ADDENDUM NO. 1
TO
CITY OF AUBURN, MAINE
2017 RECONSTRUCTION PROJECT
April 25, 2017

This addendum amends and /or supplements the bid documents as indicated below. Only these items alter the bid documents. Any verbal discussions or responses are hereby declared null and void. Please acknowledge this addendum on the attached Bid Form.

APPENDIX A

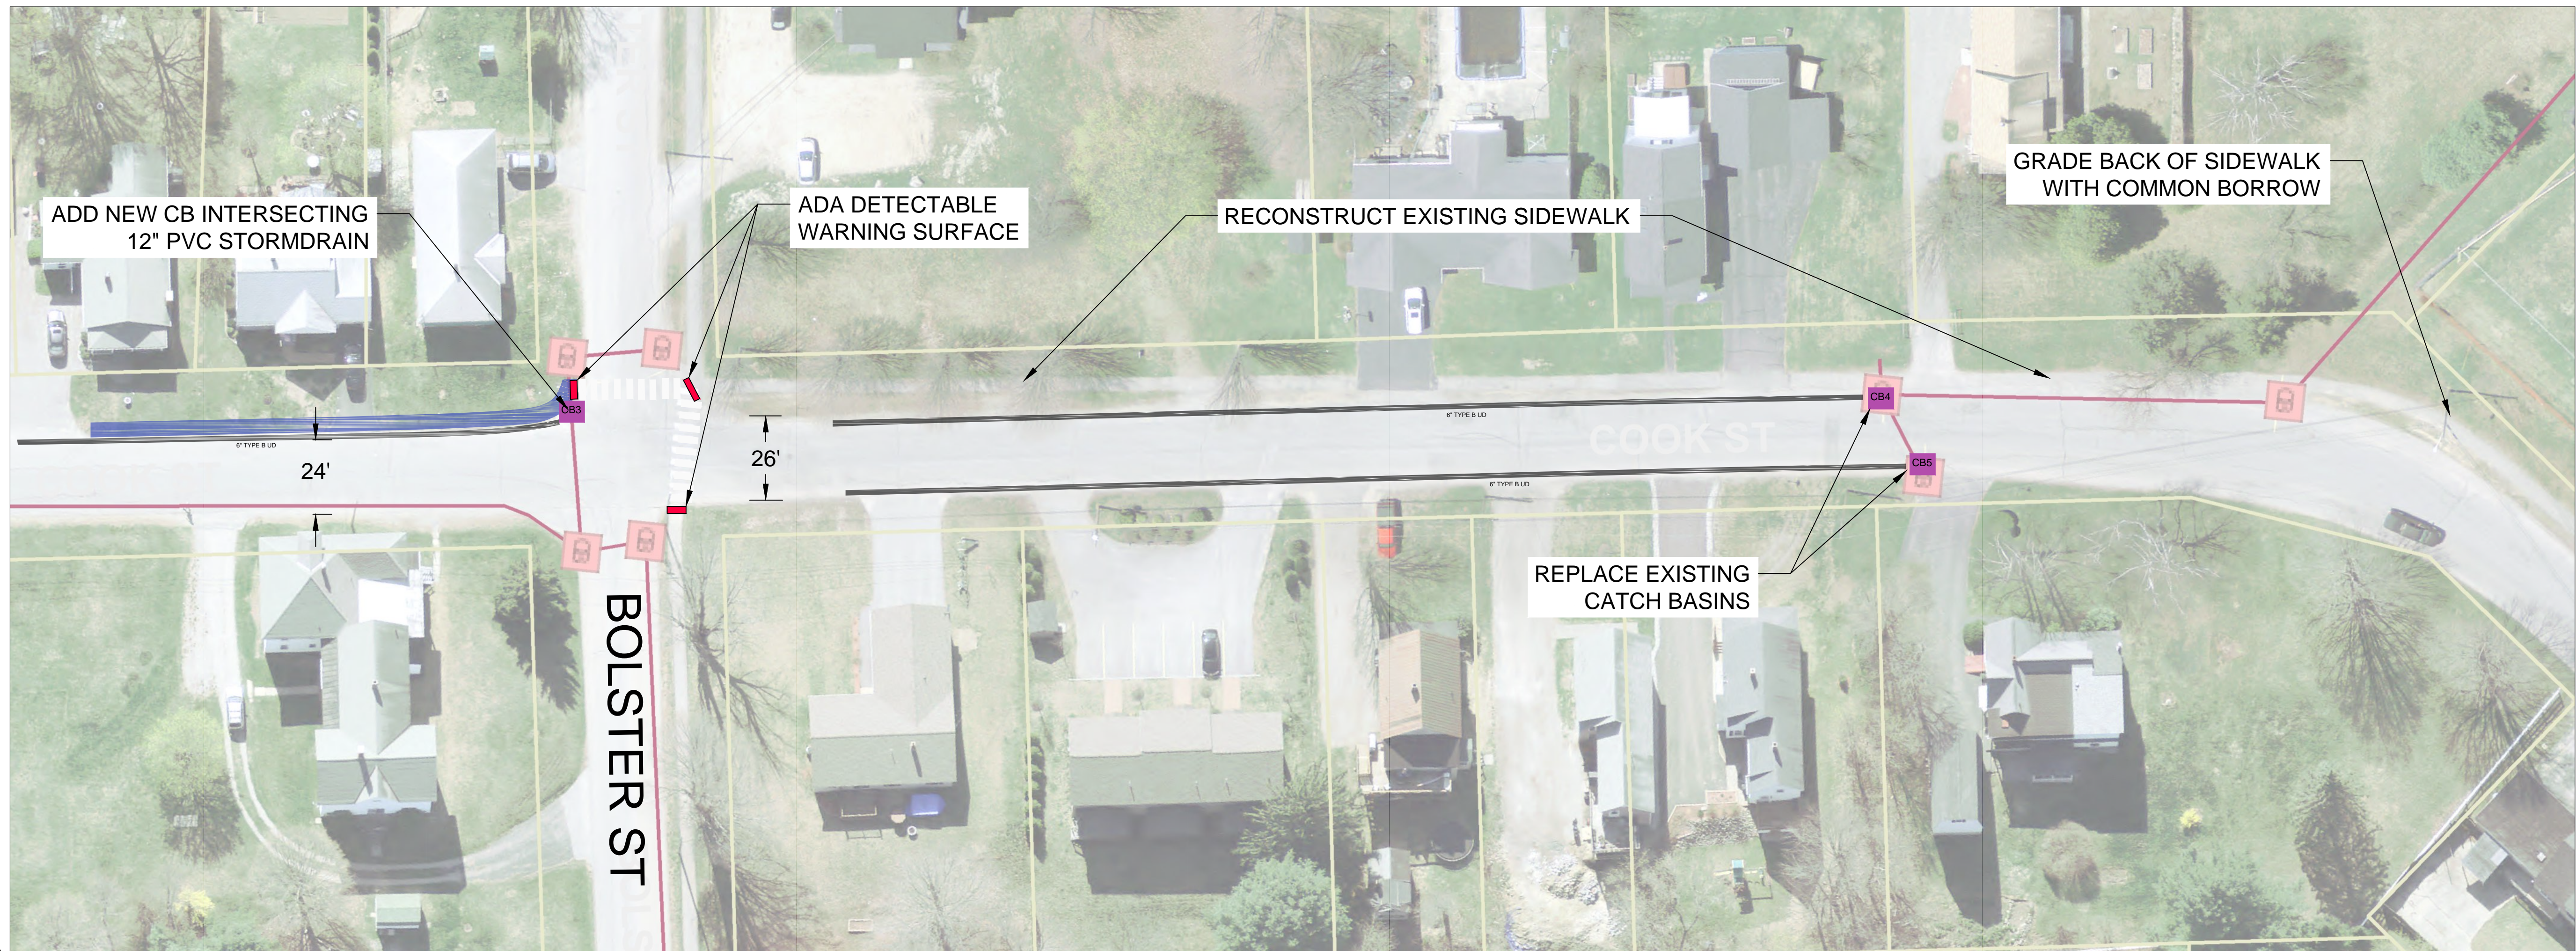
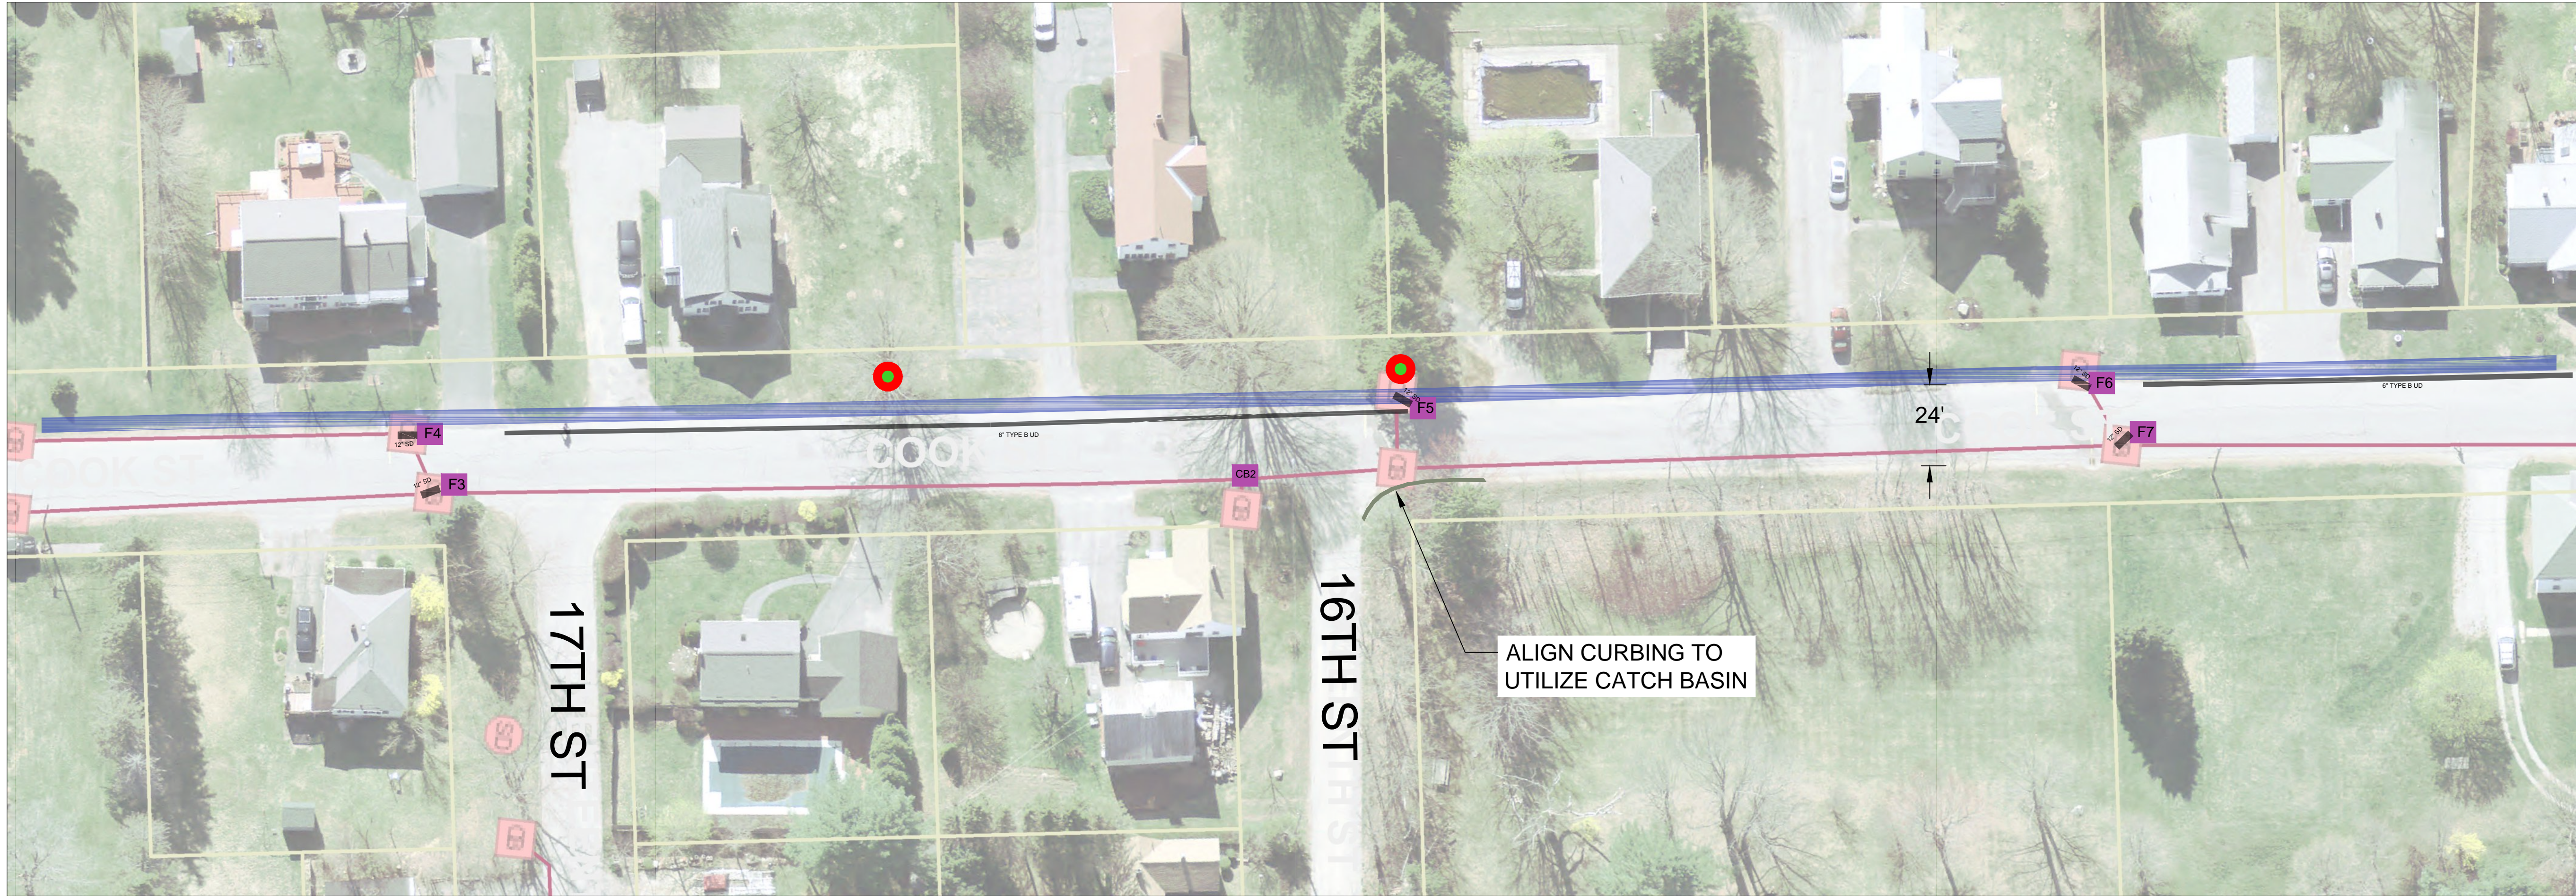
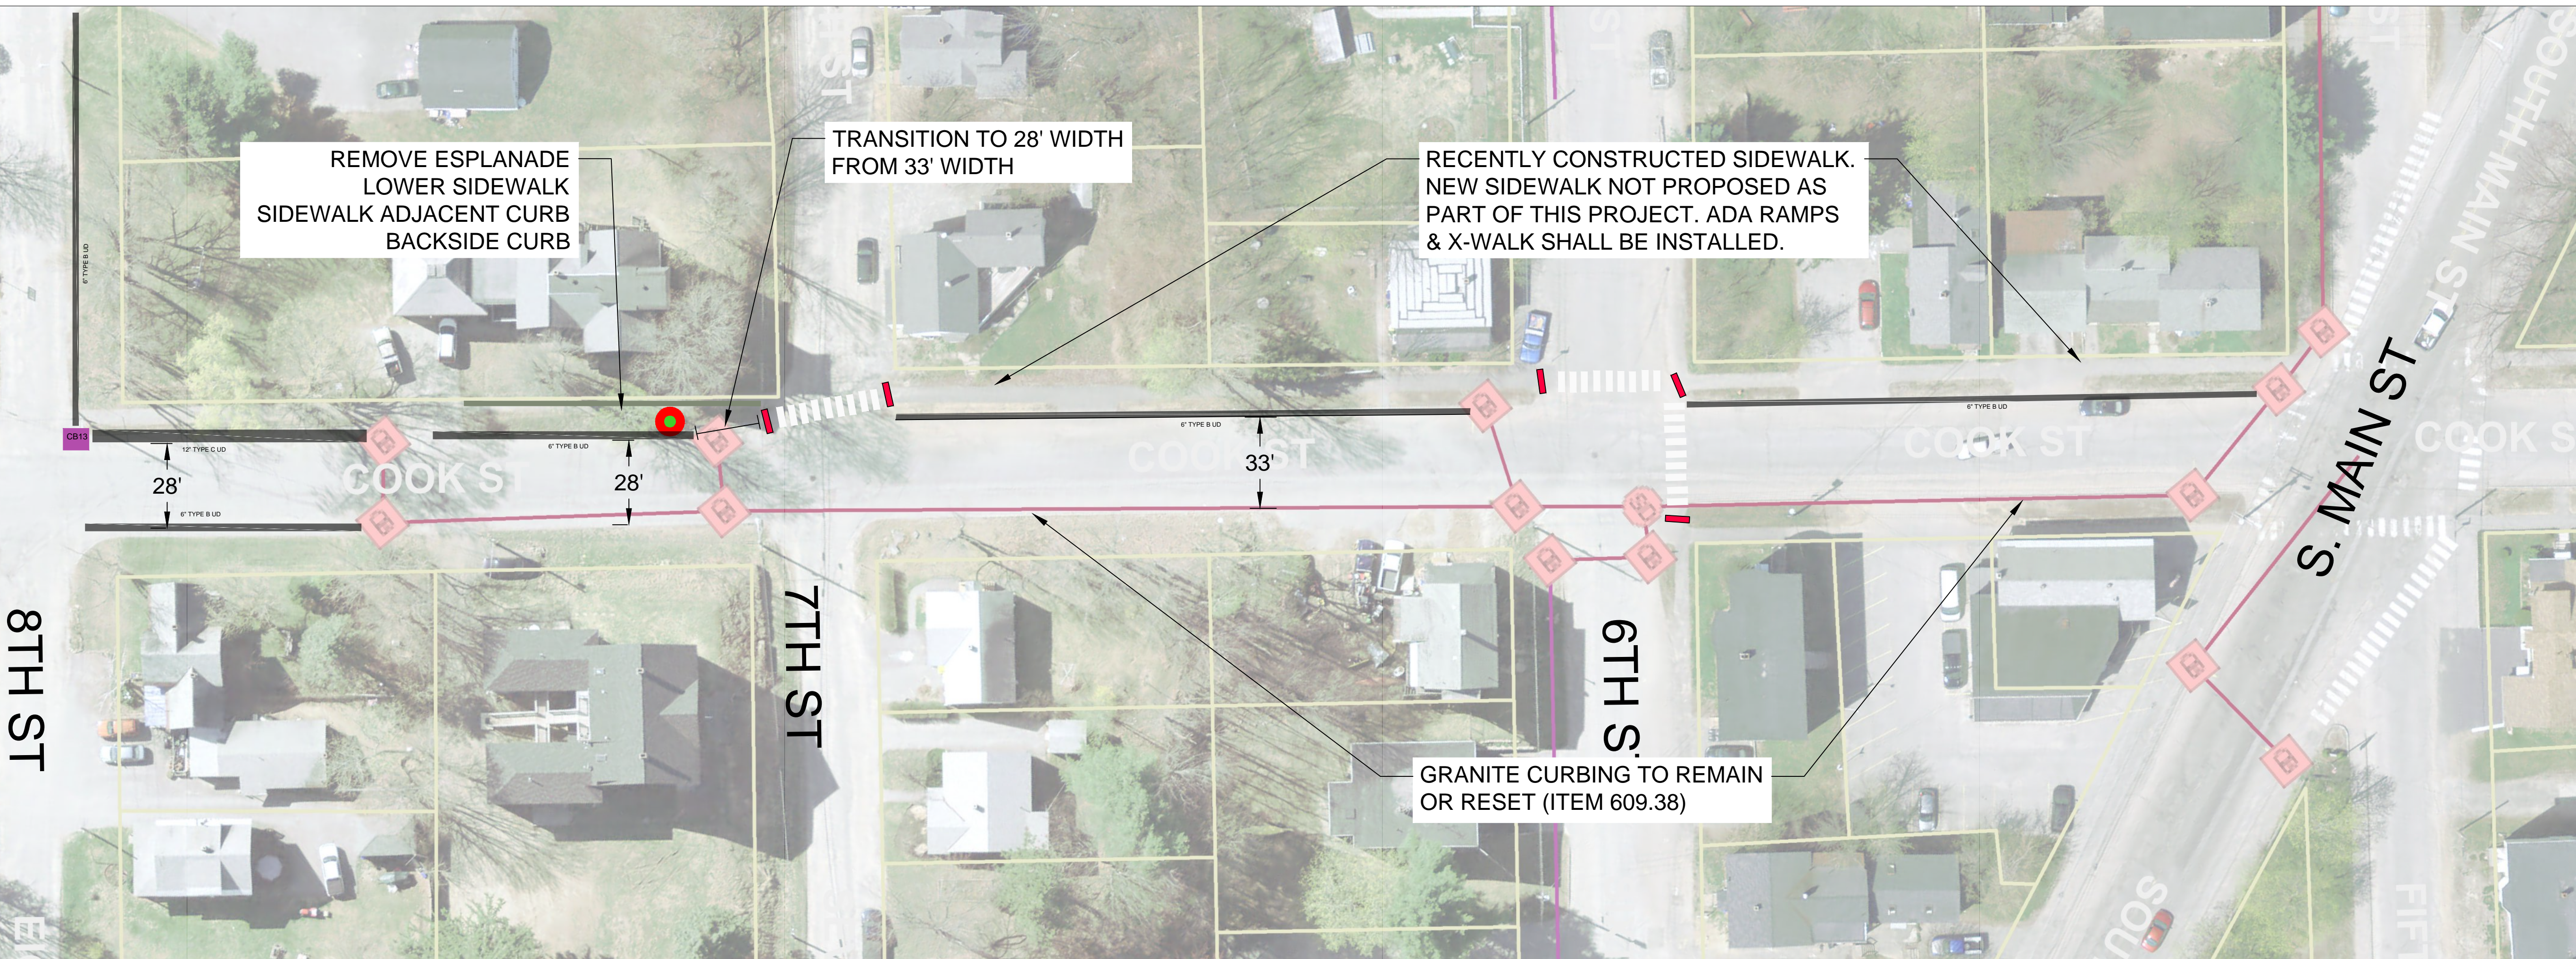
Question: The listed out road widths in the Scope of Work Section is the proposed widths?

Answer: Correct, the plan is to keep a consistent road width per section of road close to what exists. Example Cook Street from South Main Street to Bolster Street is between 22.5' and 25' in width, so proposing to carry it as 24' width. The widths can also be found on Appendix A.
